**WESTSIDE COMMUNITY
CENTER**
ACCESSIBILITY SURVEY

June, 2007

**CITY OF SANTA
BARBARA**

Building - Photo # 6

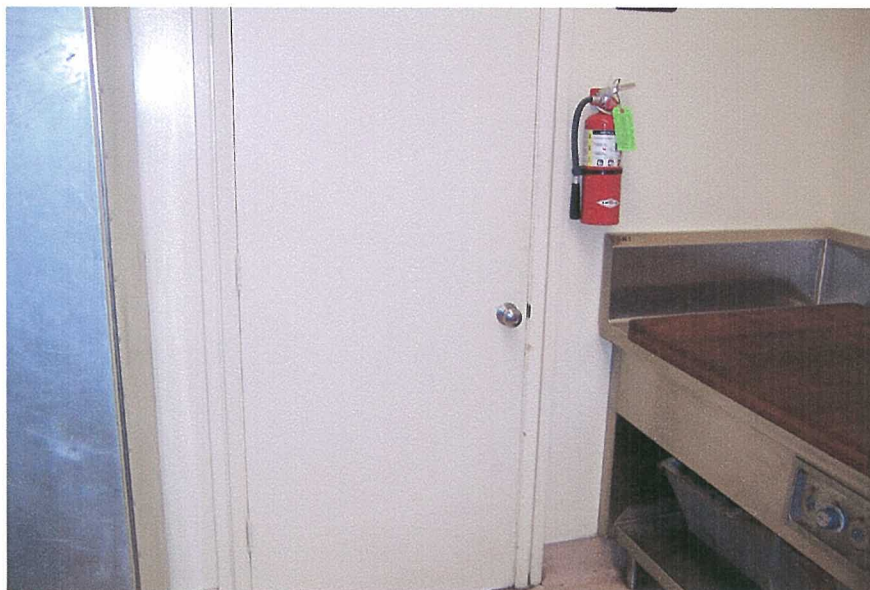
*Hardware is not accessible type. No tactile/Braille room
identification sign.*

Building - Photo # 13

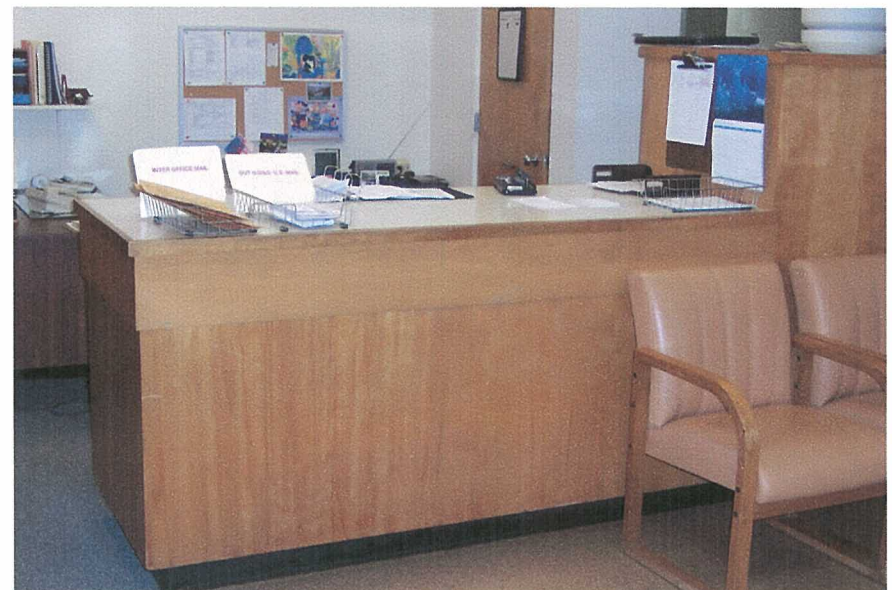
No fire tactile/Braille "EXIT" sign provided. Stored items further reduces the minimum required path of travel.

Permanent room & space signs.	Raised letters & Braille, on wall adjacent to latch side of door, 60" above floor, contrasting color, no obstacles within 3" of sign.	None. Photo #: 13	ADAAG: 4.1.2(7); 4.30.4 & 4.40.5 T24: 1117B.5.9; 1117B.5.6	Provide the required tactile permanent room signage.	1	JOB	\$100	\$100	3

Building - Photo # 19

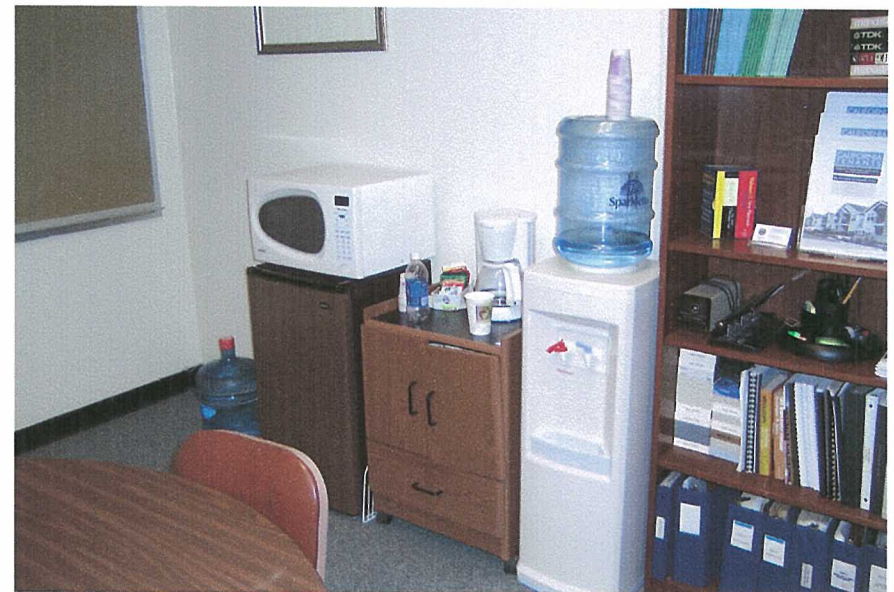
Small kitchenette does not have the required wheelchair maneuverable clearance.

Building - Photo # 22

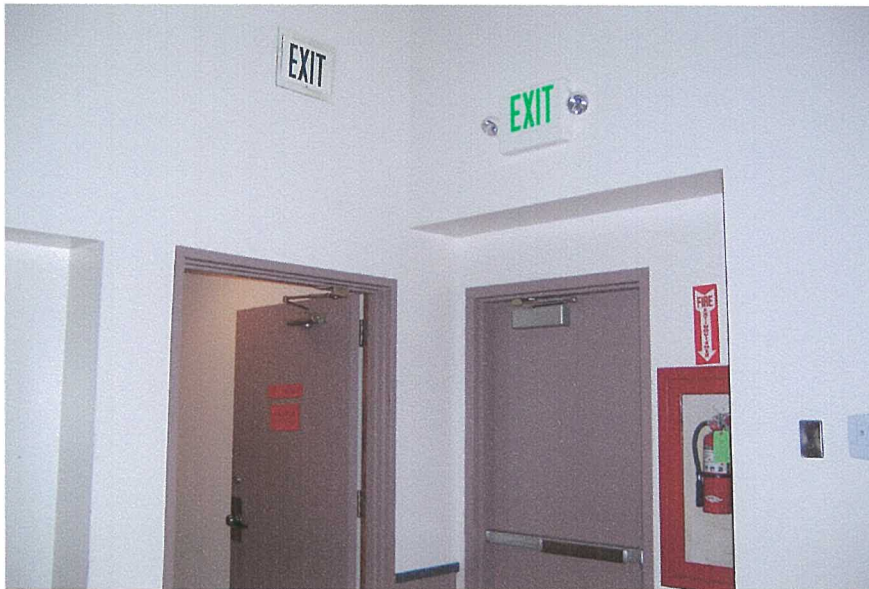
Table does not have the require knee clearance - 26 1/4" high.

Building - Photo # 23

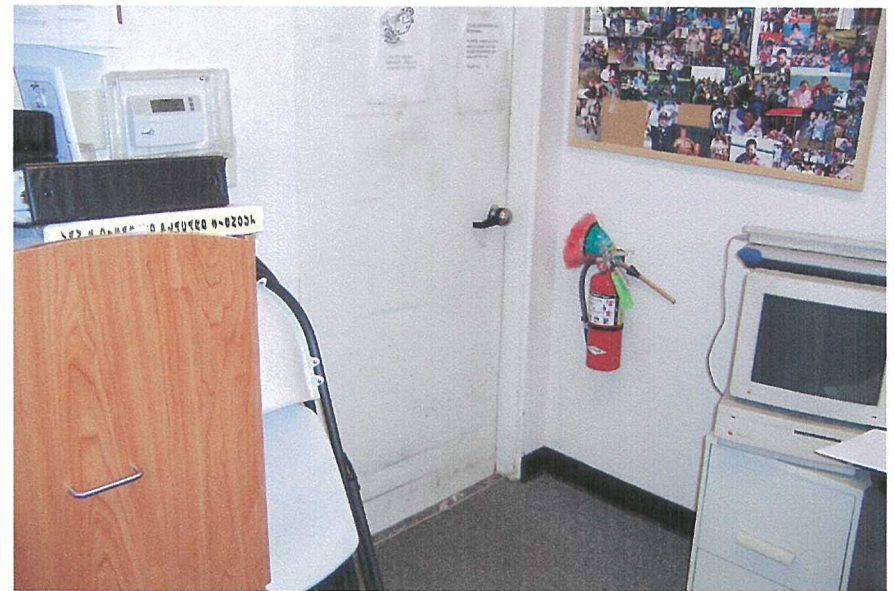
*No fire tactile and Braille "EXIT" sign provided.
Hardware is not accessible type. No tactile/Braille room
identification sign.*

Door opening hardware, type.	Lever type, panic bars, push-pull or other operable hardware with single effort without requiring tight grasping.	Hardware not accessible type. Photo #: 23	ADAAG: 4.13.9 T24: 1133B.2.5.1	Provide lever type or other accessible hardware, mounted between 36" to 44" high.	1	JOB	\$390	\$390	2

Building - Photo # 2

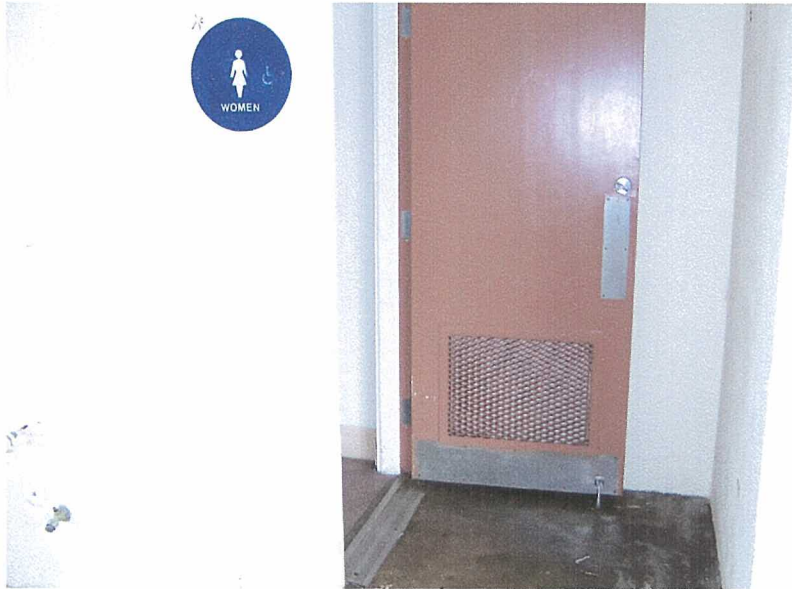
Sink does not have the required knee clearance - 25 1/2" high and 31 1/2" to the top.

Building - Photo # 1

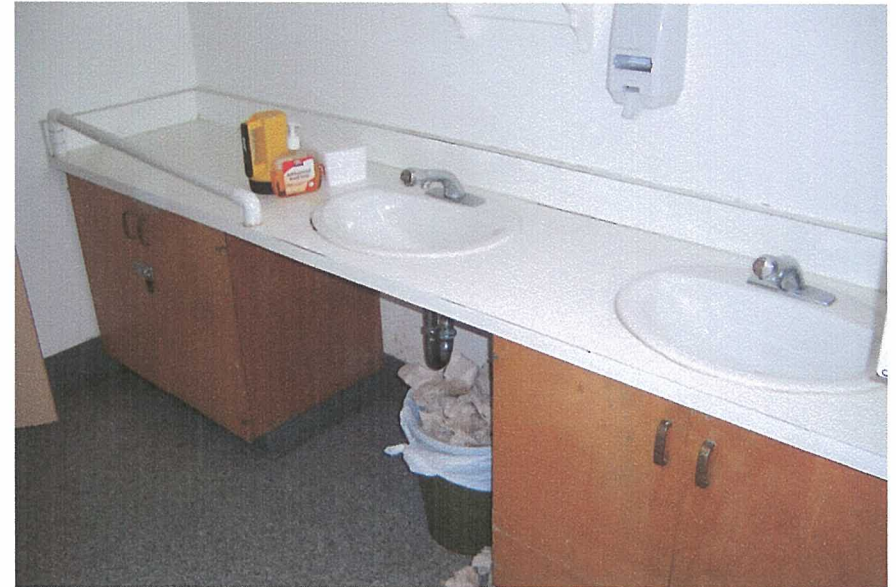
*Men's restroom door does not have a compliant sign.
Hardware is not accessible type.*

Door opening hardware, type.	Lever type, panic bars, push-pull or other operable hardware with single effort without requiring tight grasping.	Hardware not accessible type. Photo #: 1	ADAAG: 4.13.9 T24: 1133B.2.5.1	Provide lever type or other accessible hardware, mounted between 36" to 44" high.	1	JOB	\$390	\$390	2
------------------------------	---	---	-----------------------------------	---	---	-----	-------	-------	---

Permanent room & space signs.	Raised letters & Braille, on wall adjacent to latch side of door, 60" above floor, contrasting color, no obstacles within 3" of sign.	None. Photo #: 1	ADAAG: 4.1.2(7); 4.30.4 & 4.40.5 T24: 1117B.5.9; 1117B.5.6	Provide the required tactile permanent room signage.	1	JOB	\$100	\$100	3
-------------------------------	---	---------------------	---	--	---	-----	-------	-------	---

Building - Photo # 4

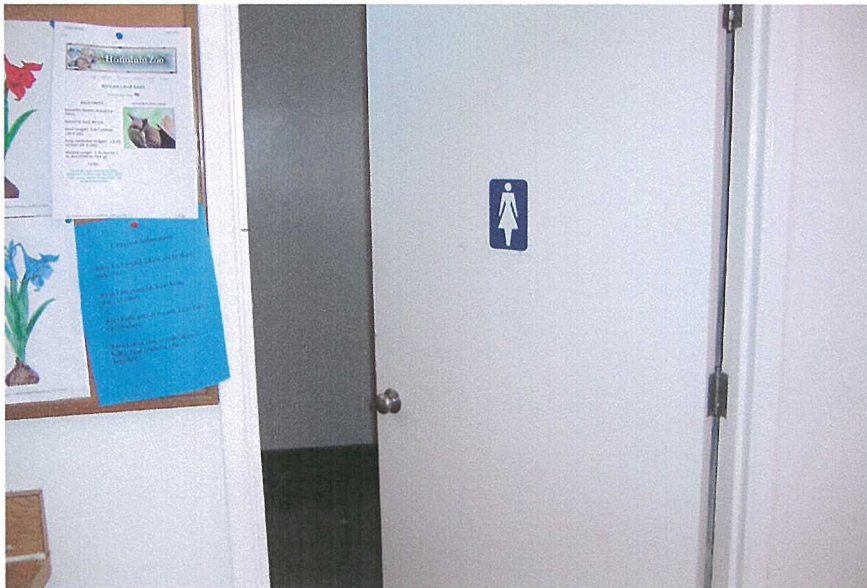
Narrow Women's semi-ambulatory stall is not compliant, since there is no other accessible restroom in this building.
